From: Howard, Leslie Ann CIV USN BRAC PMO SAN CA (USA) [leslie.howard@navy.mil]
Sent: Friday, October 23, 2020 12:50 PM
To: White, Jeff@Waterboards [Jeff.White@Waterboards.ca.gov]; Bacey, Juanita@DTSC [Juanita.Bacey@dtsc.ca.gov]; amy.brownell@sfdph.org; Low, Tina@Waterboards [Tina.Low@waterboards.ca.gov]; Ueno, Karen [Ueno.Karen@epa.gov]
CC: Robinson, Derek J CIV USN NAVFAC SW SAN CA (USA) [derek.j.robinson1@navy.mil]; Egan, Jamie [Jamie.Egan@jacobs.com]; Pauly, Brooks CIV USN BRAC PMO SAN CA (USA) [brooks.pauly@navy.mil]; Stoick, Paul T CIV USN NAVFAC SW SAN CA (USA) [paul.stoick@navy.mil]
Subject: HPNS Parcel E-2 Revised Draft Final Phase II RACR
Attachments: RTC - DF_RACR_Parcel E-2_Rf.docx; RTC - Attachments.pdf; FINAL_RACR_PE2_REDLINE.docx; FINAL_RACR_PE2_REDLINE.pdf; Table 5_FW_Conf Table (Rev1).pdf; Table 6_FW_Lead Excavation Conf Table.pdf; Table 7_TW Chemical Analysis Results_RC.pdf; 500506-B24-Fig 6 (Rev2).pdf; 500506-B25 Fig 7 (Rev2).pdf; 500506-B26 Fig 8 (Rev2).pdf; AppX_Table 1_Freshwater Wetlands Waste Characterization Analysis.pdf; AppX_Table 2_FW Waste Soil Metals_PreTreatment Characterization.pdf; AppX_Table 3_Parcel F Waste Soil Results.pdf; App Y_Water Quality Da

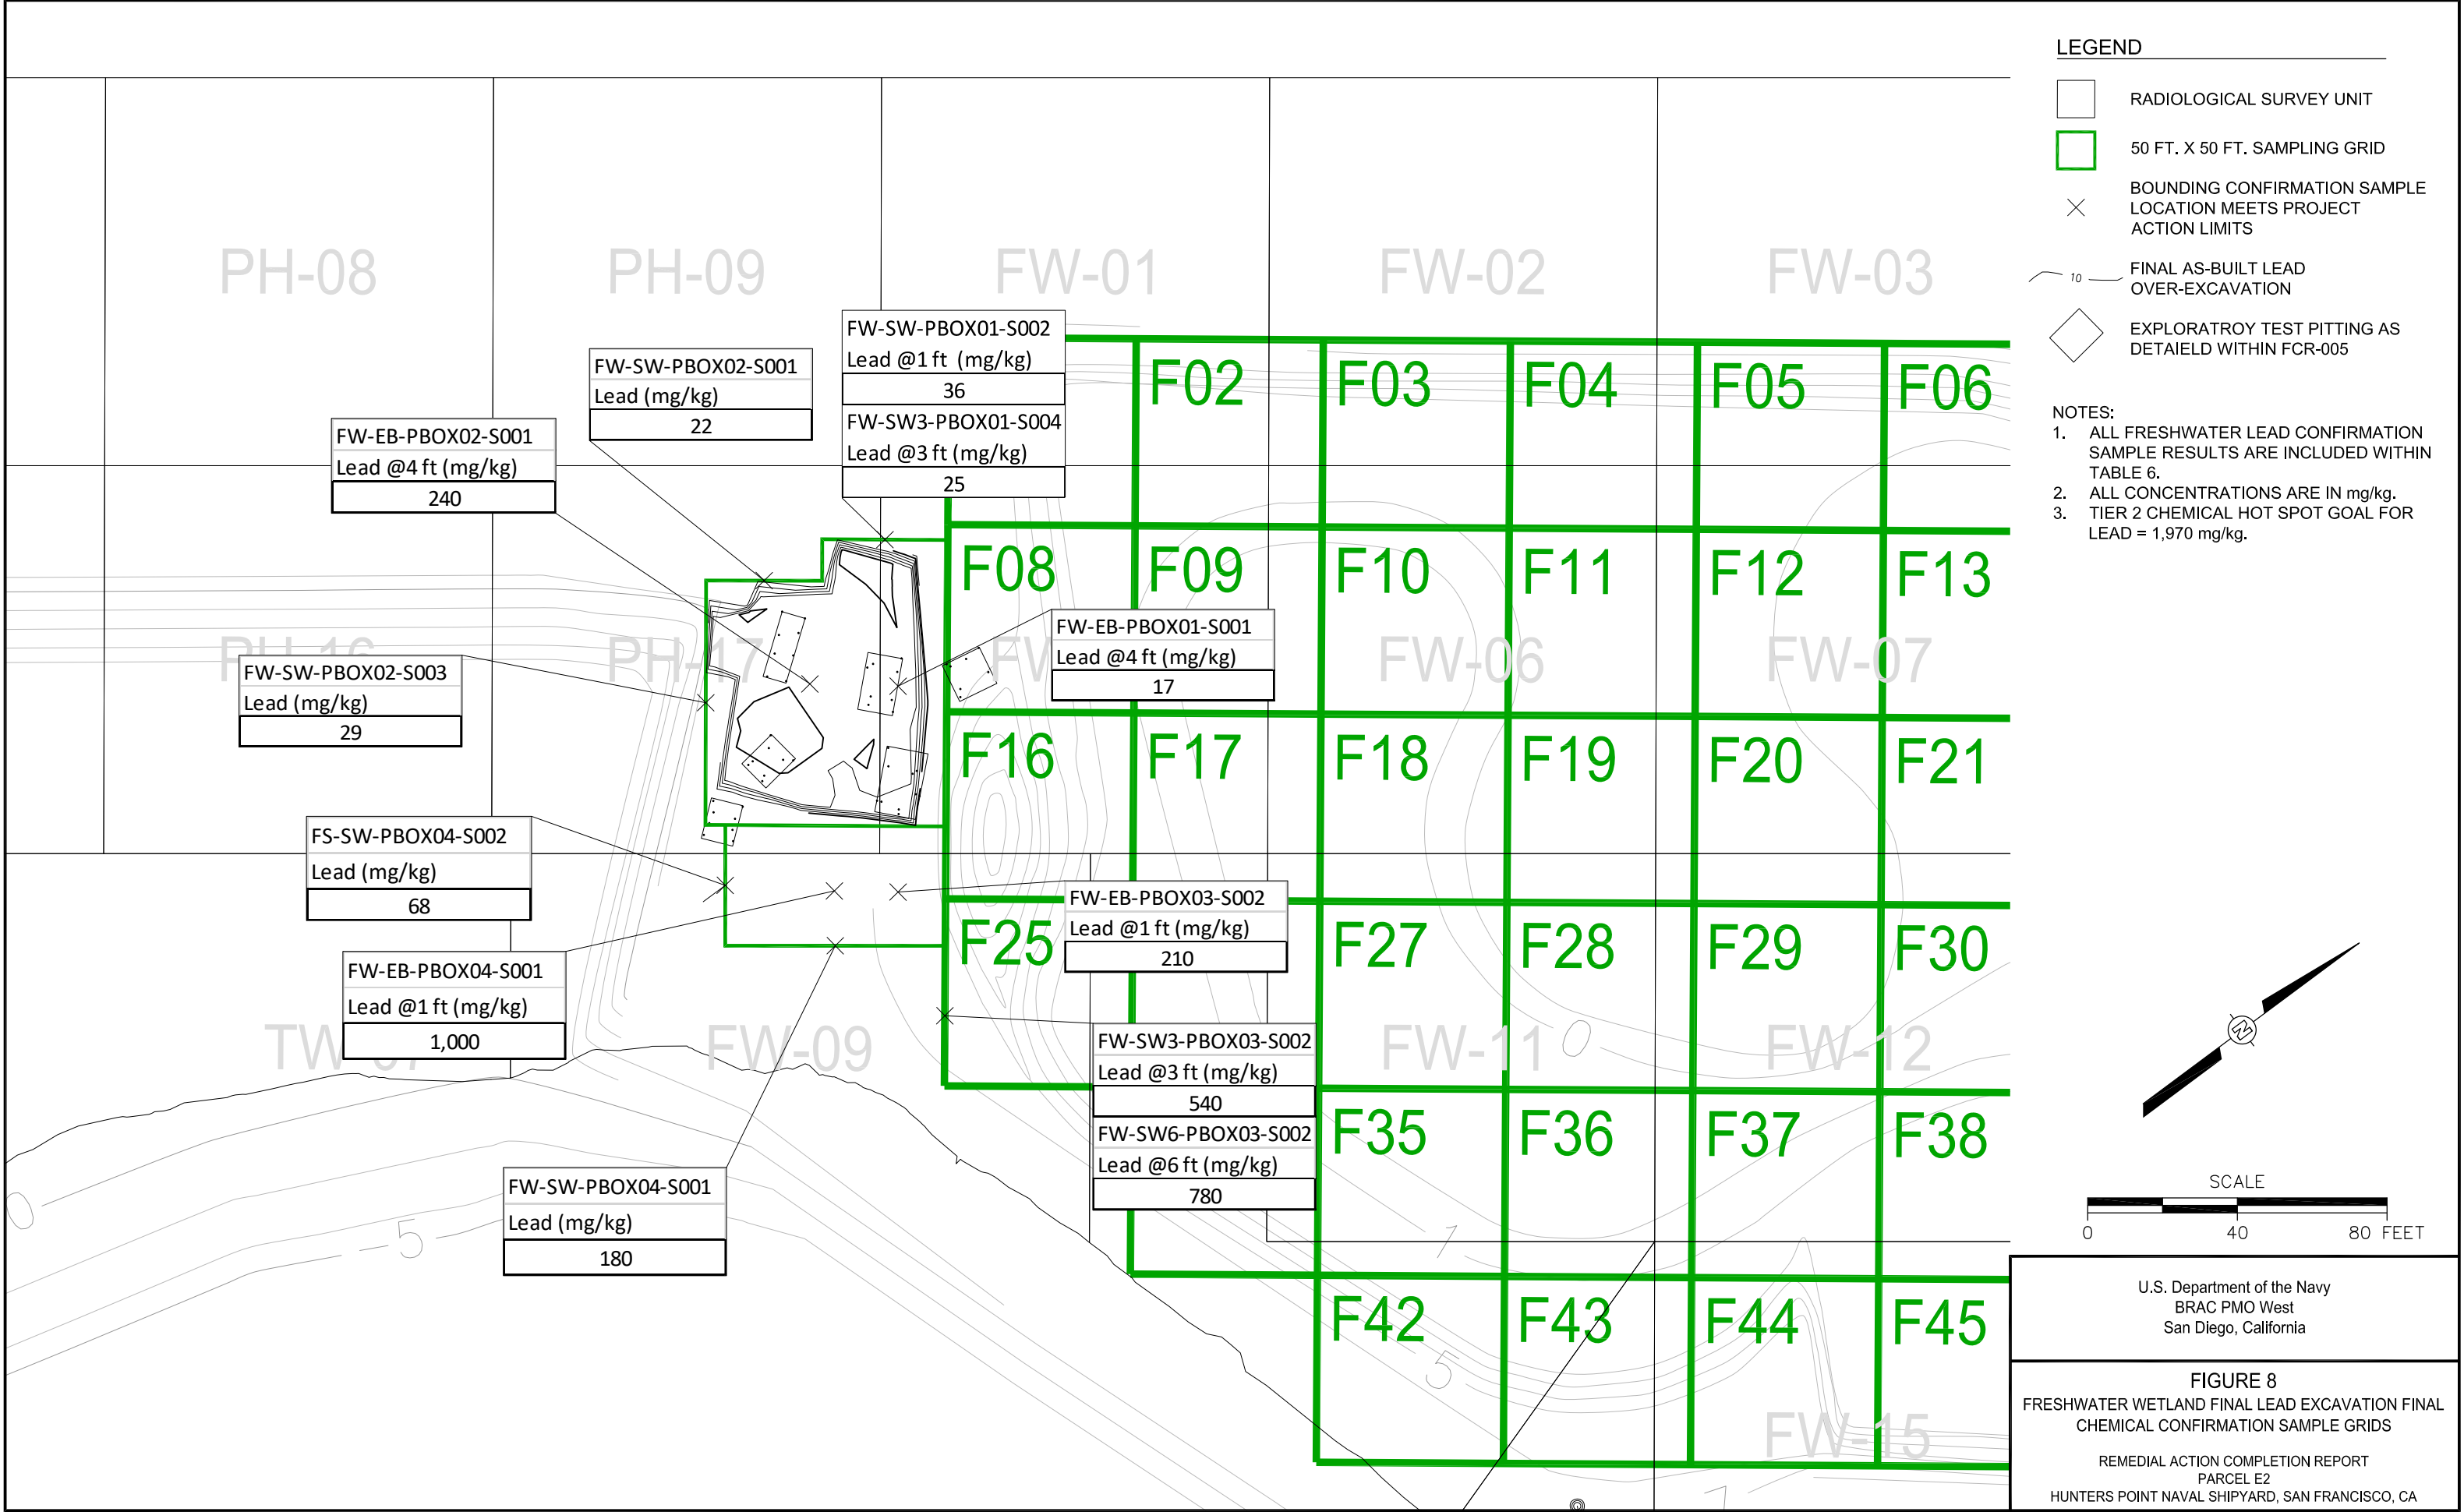
A copy of the revised Figure 6 has been in package for advanced review.
<p>10. Figure 7 Tidal Wetland Final Chemical Confirmation Sample Grids</p> <ul style="list-style-type: none"> a) An explanation of what the red font in the sample results should be added to the legend. b) A hot spot goal is provided only for lead on this figure, when copper results are also presented on this figure. The hot spot goal for copper should be included as notes on this figure. c) Only two sample locations are indicated on this figure, when a sample should have been collected from each sample grid. This figure should be revised to include all sample locations. 	<p>For clarity, the following notes have been added:</p> <ul style="list-style-type: none"> a) Sample results shown in red indicate project action limit. b) Consistent with the changes made, Cu, TPH, and PCBs have been added. c) The CAD layer showing the additional sample locations was inadvertently turned off. Consistent with the changes made, the layer now correctly shows the “x” symbol where all confirmation samples were collected. Boxes will only be shown for those sample locations where data collected, including all sample locations, are included in Tables 6 and 7. d) Consistent with the changes made, a list of abbreviations has also been added: <ul style="list-style-type: none"> T – Tidal Wetlands Confirmation EB – Excavation Bottom Confirmation SW – Excavation Sidewall Confirmation N – North E – East S – South W – West Mg/kg – milligram per kilogram Pb – Lead PCB – Polychlorinated Biphenyl TPH – Total Petroleum Hydrocarbon Cu – Copper <p>A copy of the revised Figure 7 has been in package for advanced review.</p>

Remedial Action at Parcel E-2 - Dissolved Oxygen
07/1/2017- 5/1/2018

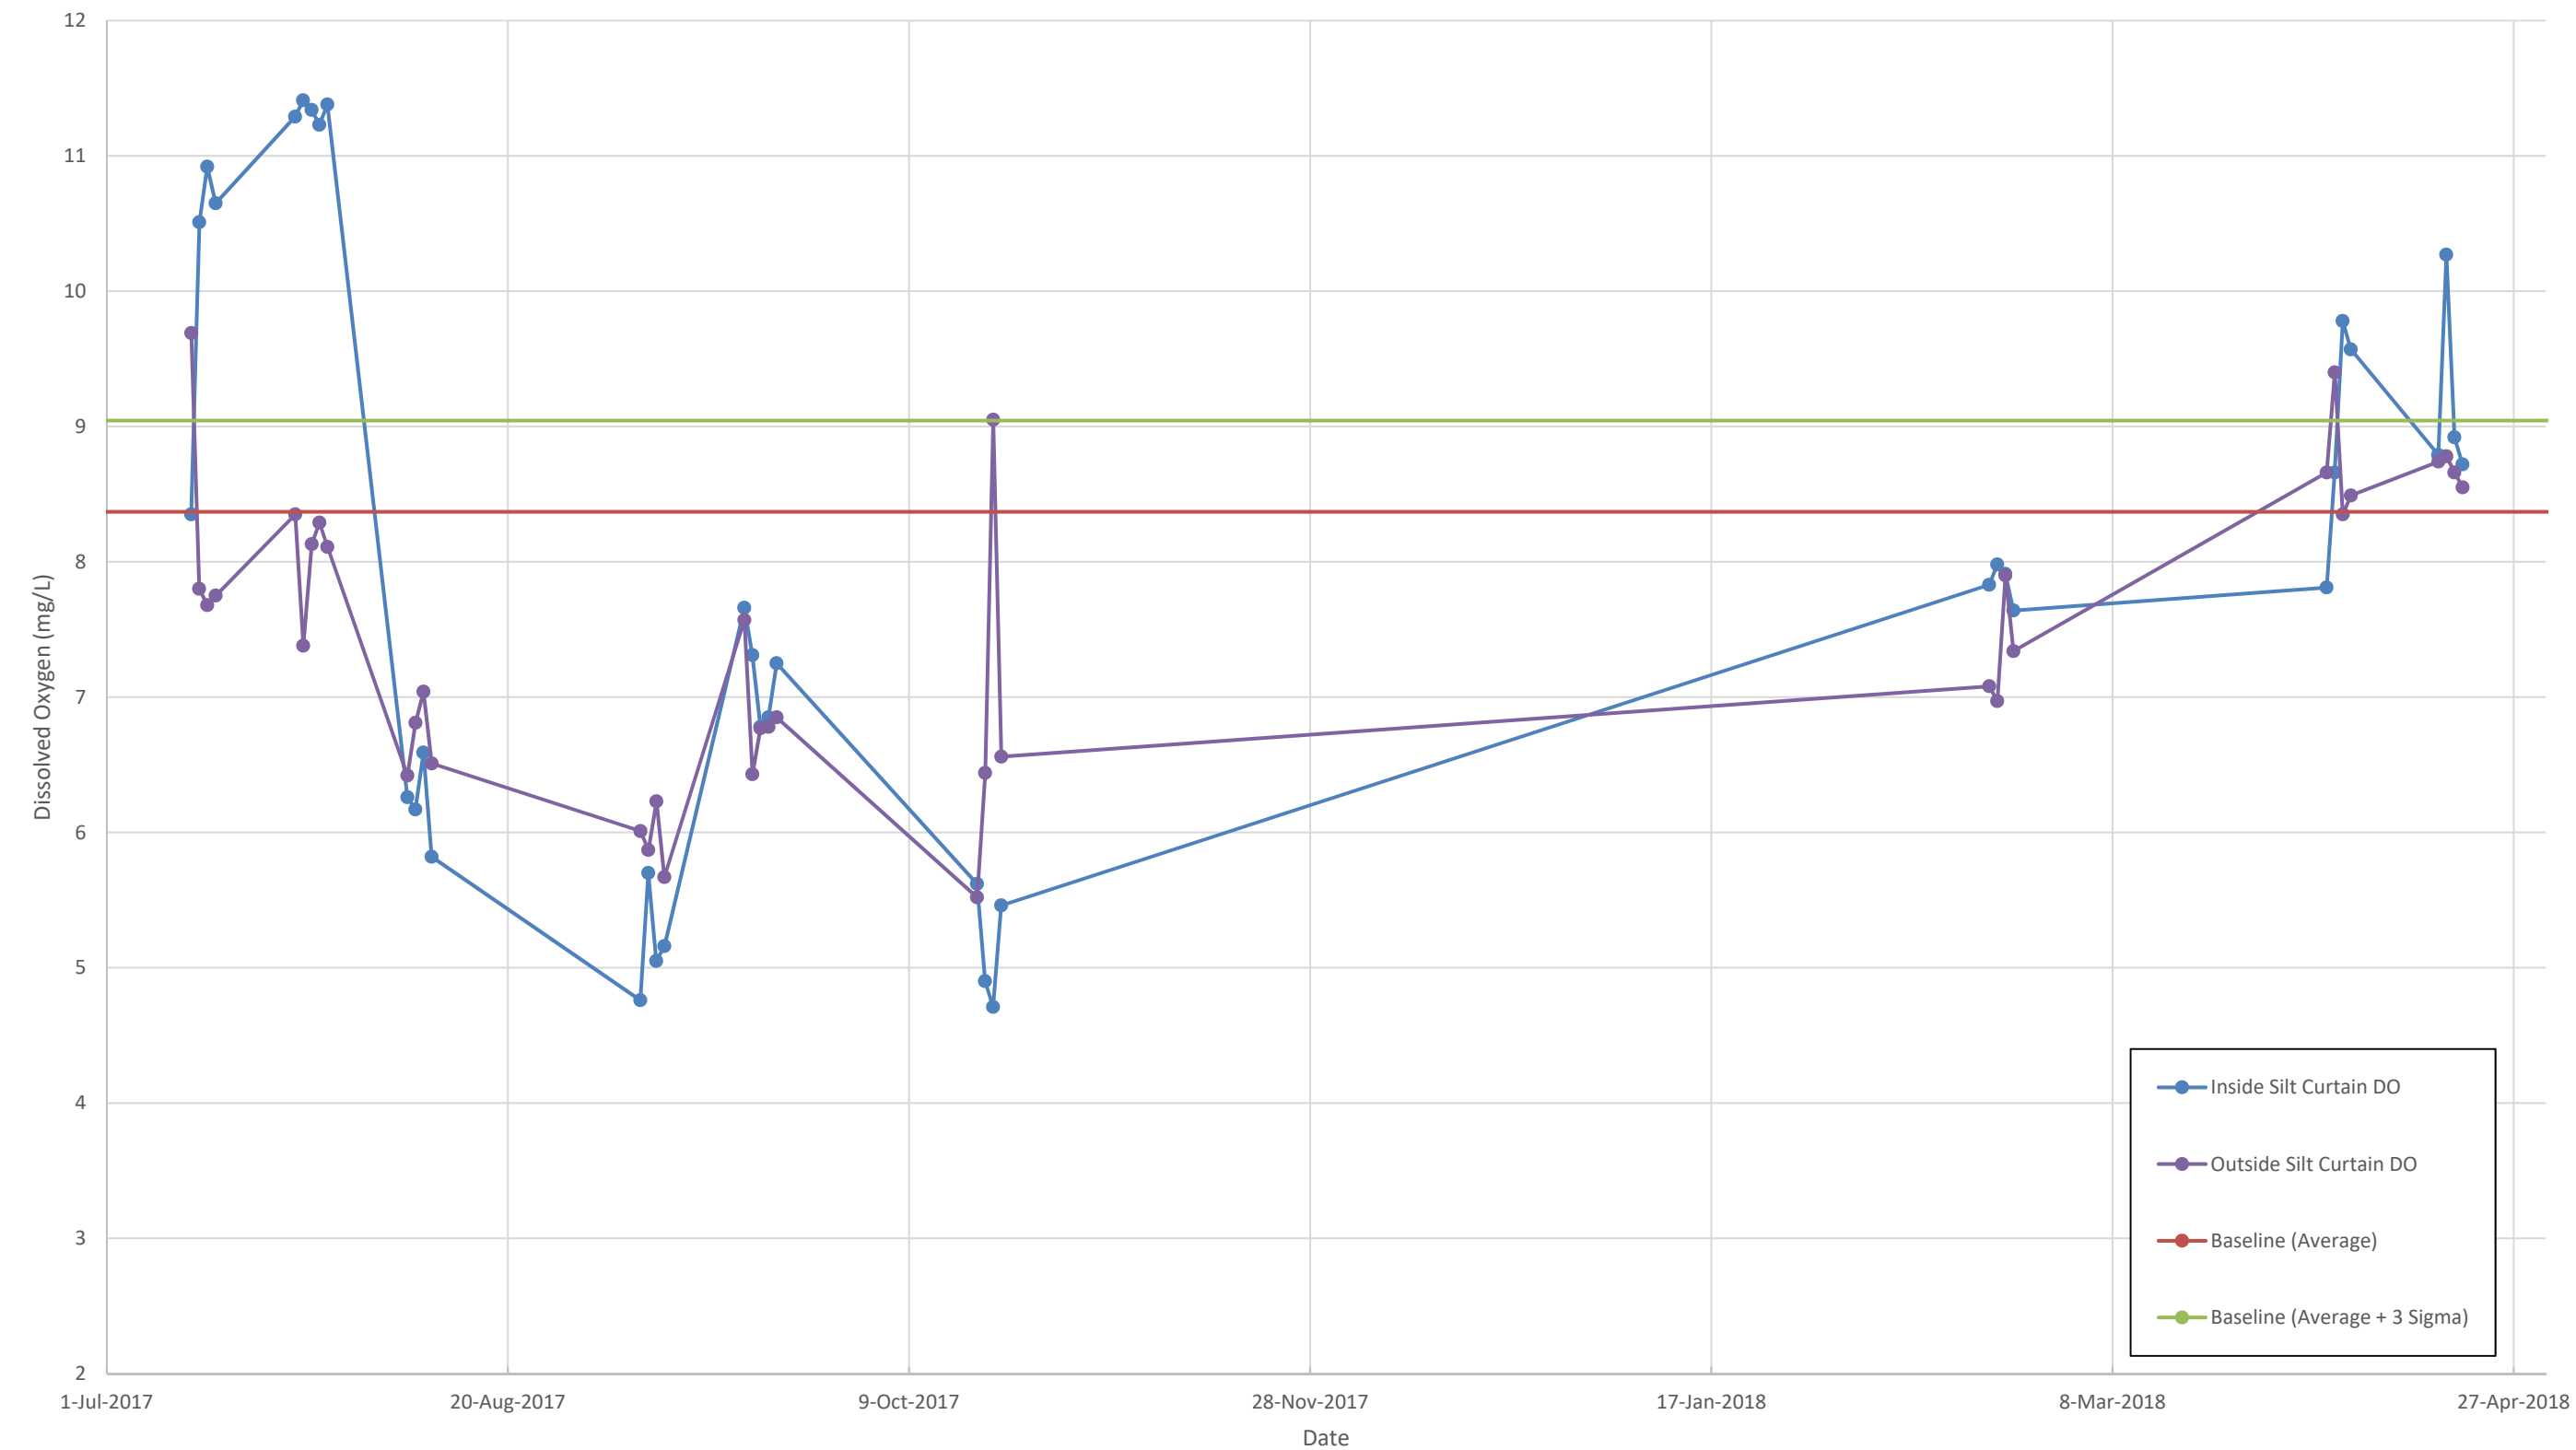
- Revised charts for Dissolved Oxygen, PH, and Turbidity (In response to DTSC comment 13)
- Appendix AA – Analytical Data and Validation Reports (in response to EPA comment 20)
